CITY OF ALBUQUERQUE

**RE: Nusenda Credit Union Admin Expansion
4100 Pan-American Freeway NE
Grading and Drainage Plan
Engineer's Stamp Date 3/15/18
Hydrology File: G16D154**

UPPER LEVEL
GRADING and
DRAINAGE PLAN
date:
3-15-18
sheet:
c101

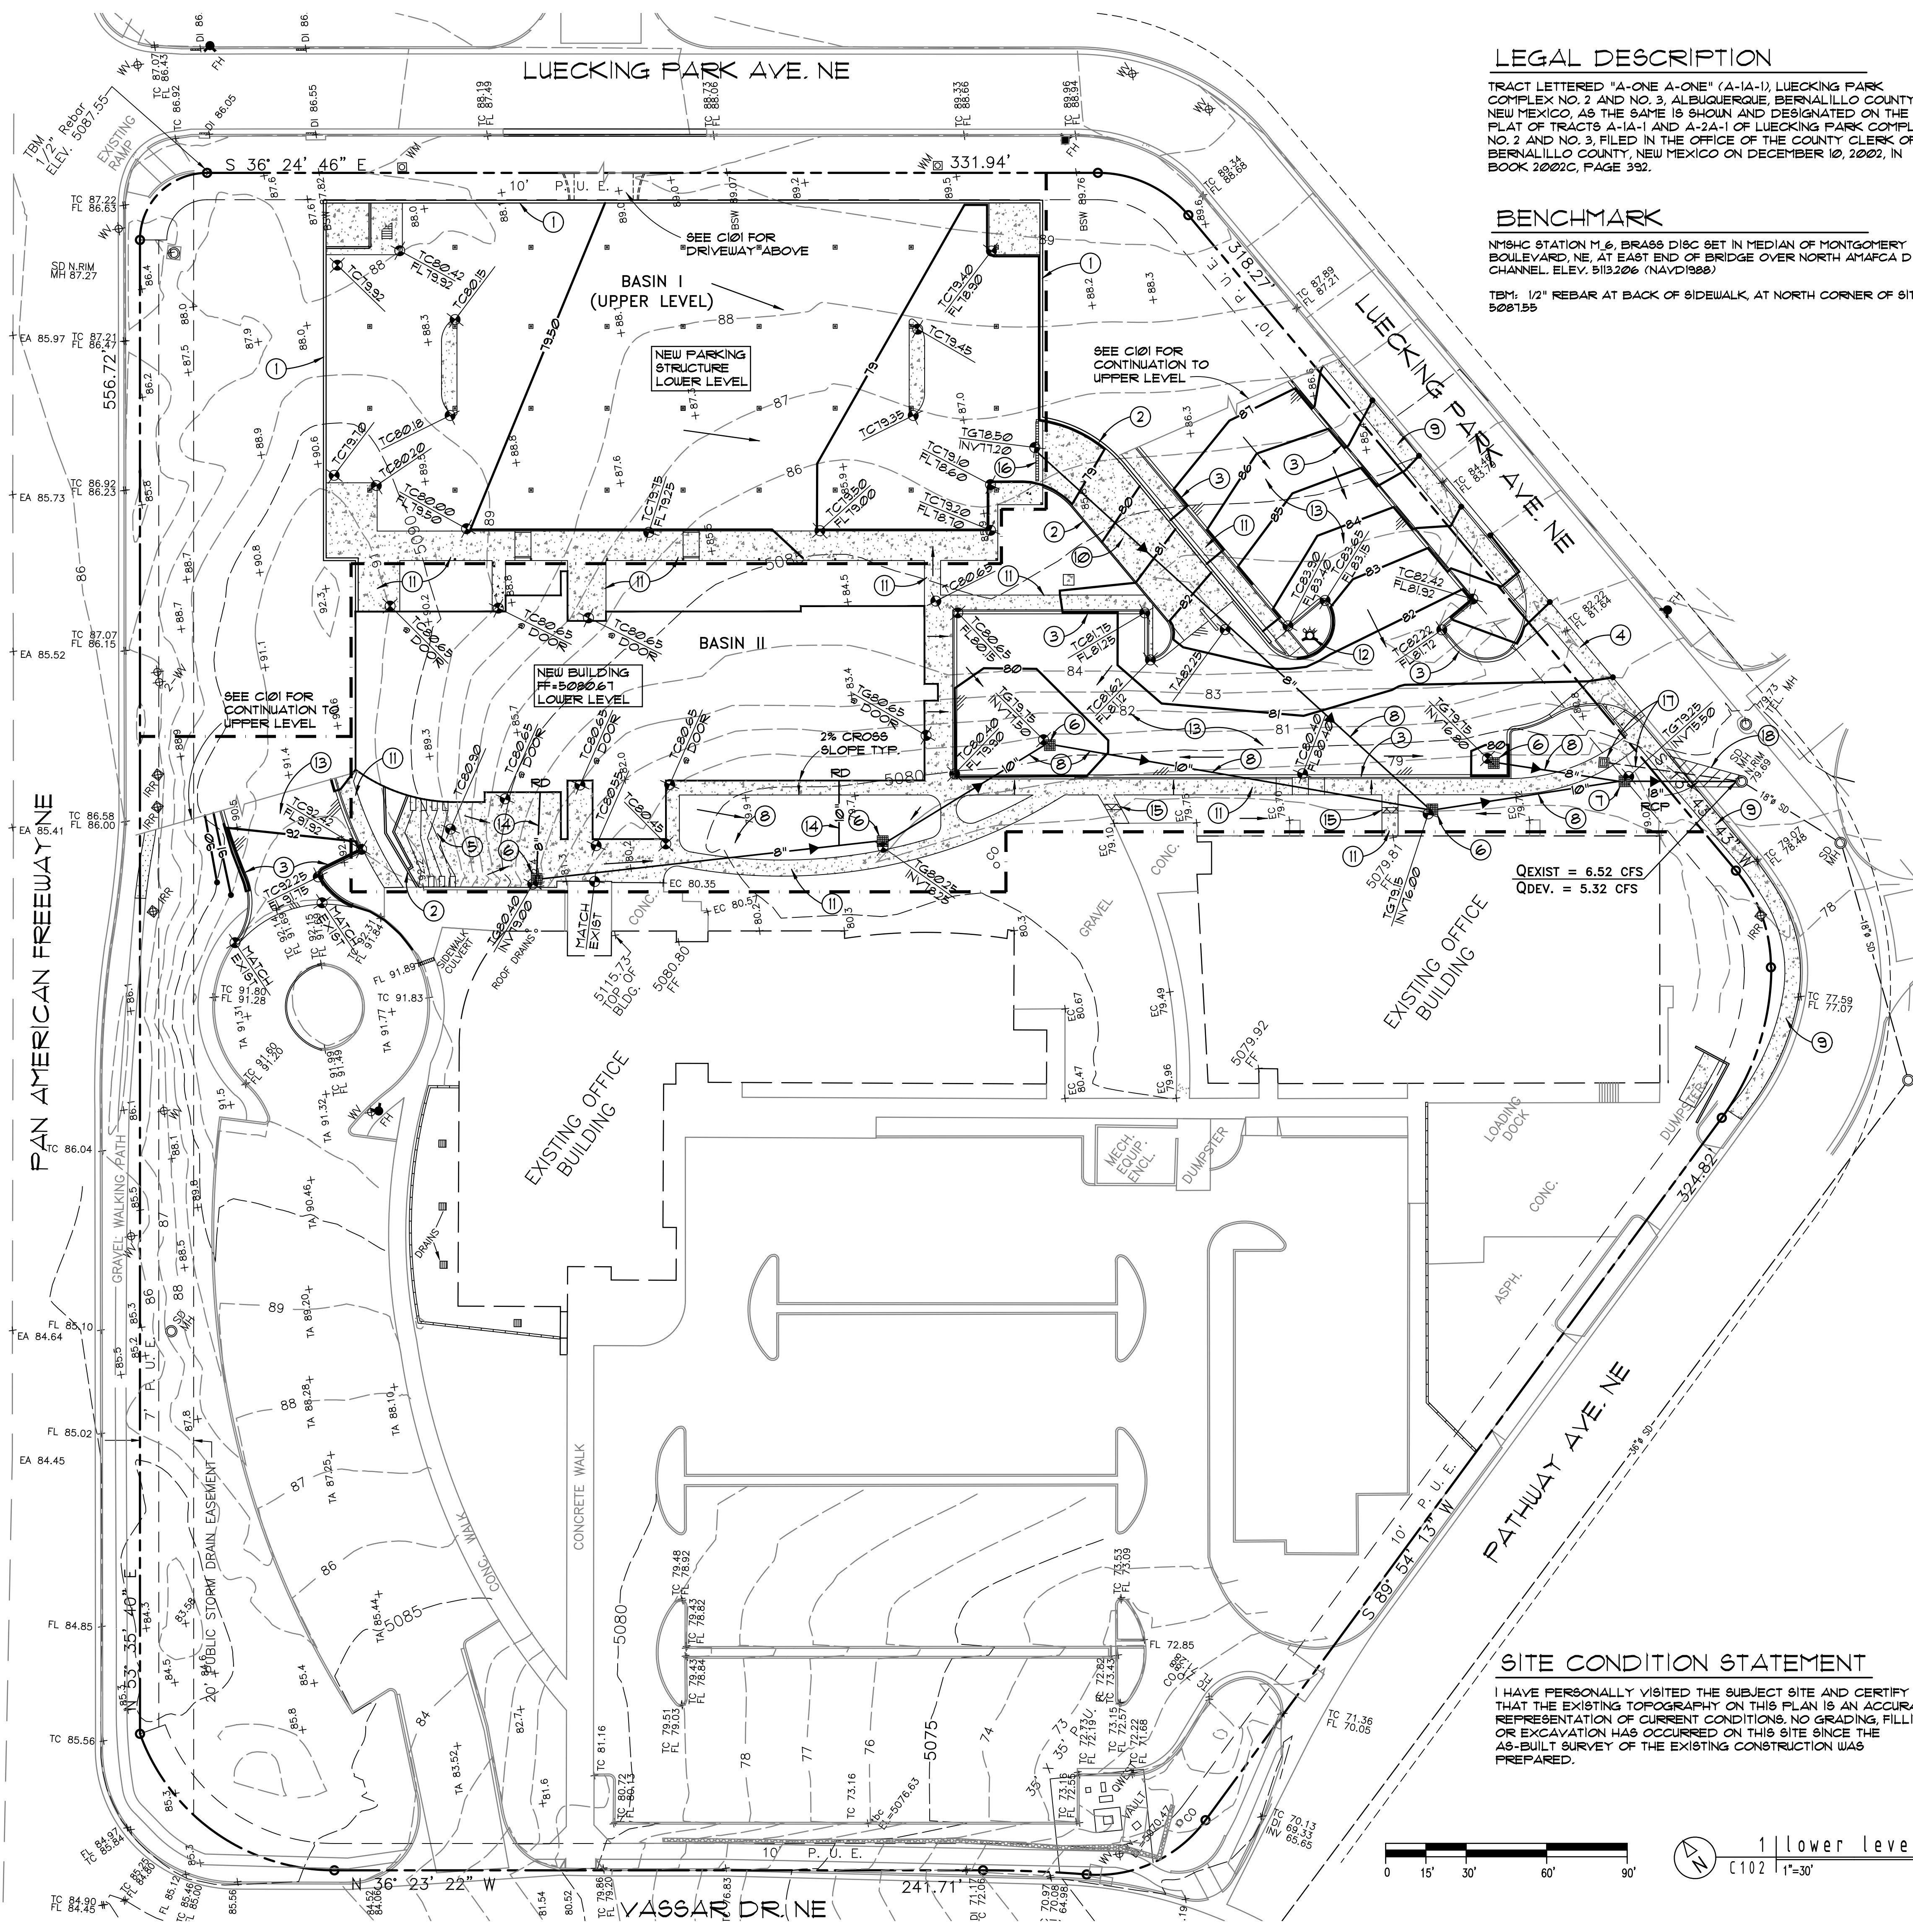
1. Please recheck your first flush calculations. I calculated a new imperious area of only 2.436Ac and first flush runoff volume of 3007CF, based on your proposed basin conditions. This results in a lower payment of Fee-In-Lieu.
2. This project will require a public Work Order for the work along Luecking. Add a note to this Grading Plan that "No work is permitted in the Public Right-of Way without an approved Work Order" or similar.
3. This project requires an ESC Plan, submitted to the Stormwater Quality Engineer (Curtis Cherne PE, ccherne@cabq.gov or 924-3420).
